TECHNICAL MEMORANDUM

To: Ray Cody and Karen Simpson, United States Environmental Protection Agency, Region 1
From: Matt Lundsted and Nick Cristofori, CEI and Bruce Jacobs and Ken Hickey, WaterVision
Subject: **Task 1 Summary Memo: A description of recently completed data collection, conceptual design, and associated tasks.**
Date: February 17, 2015

This attachment contains comments received from EPA staff following the meeting of January 13, 2015 on the conceptual design of the proposed BMP projects. Design Team responses follow each comment in italicized text.

Figure
7

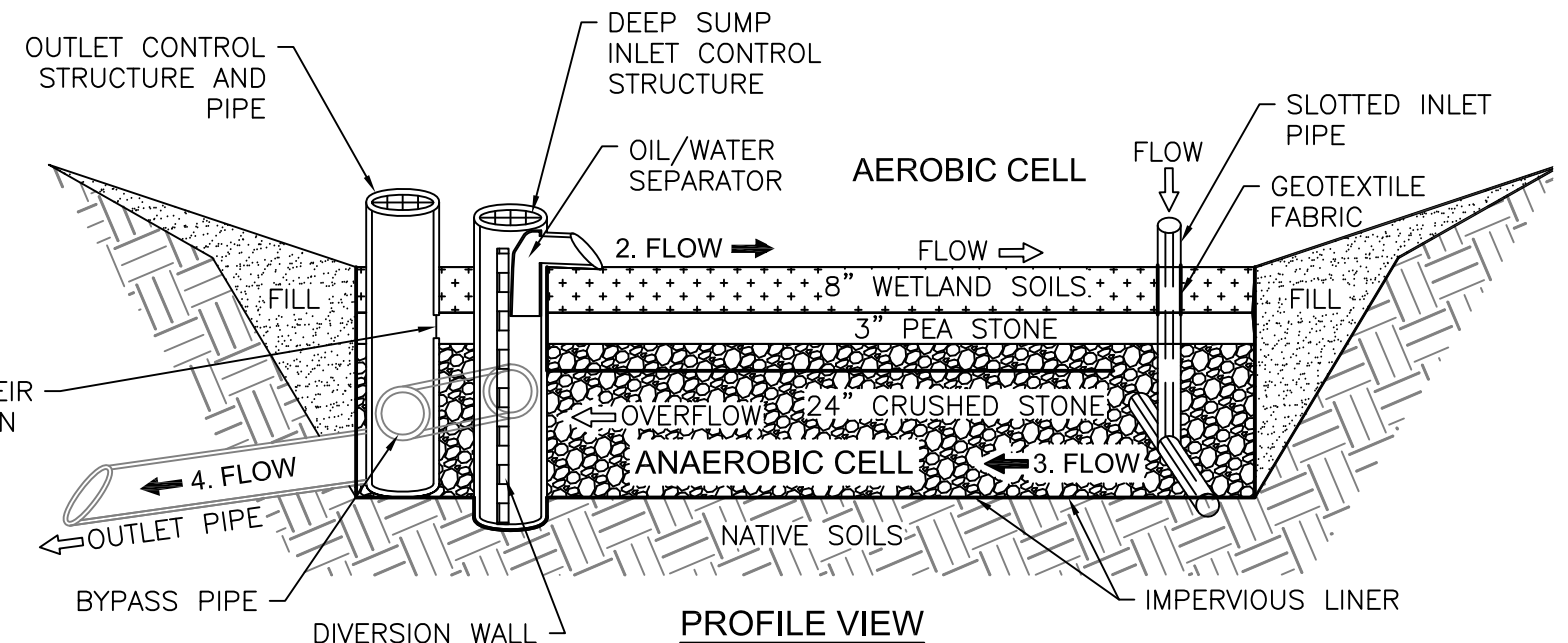
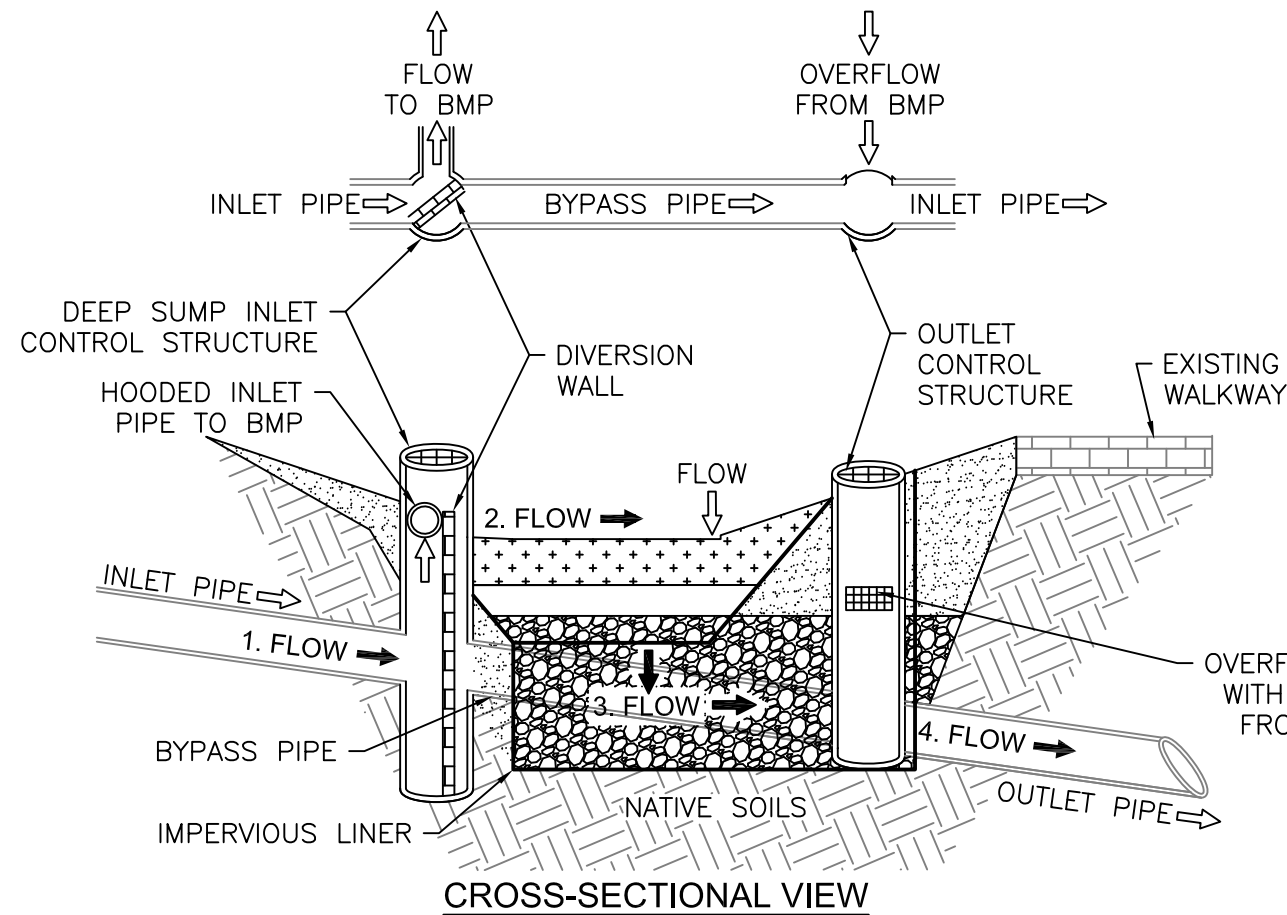
33. Design Figures. As we discussed, it would help to clarify / label the aerobic versus anaerobic zones of the treatment cells; otherwise, as we discussed, it almost appears as if the entire first of the two cells is an aerobic treatment cell and that the system only treats

Acknowledged. Revised design plans are attached to this response to clarify aerobic and anaerobic portions of each cell. Additionally, Figure 4 and Figure 7 contain cross sections for each BMP and outline a step-by-step guide to the stormwater treatment process and identifies all major design features.
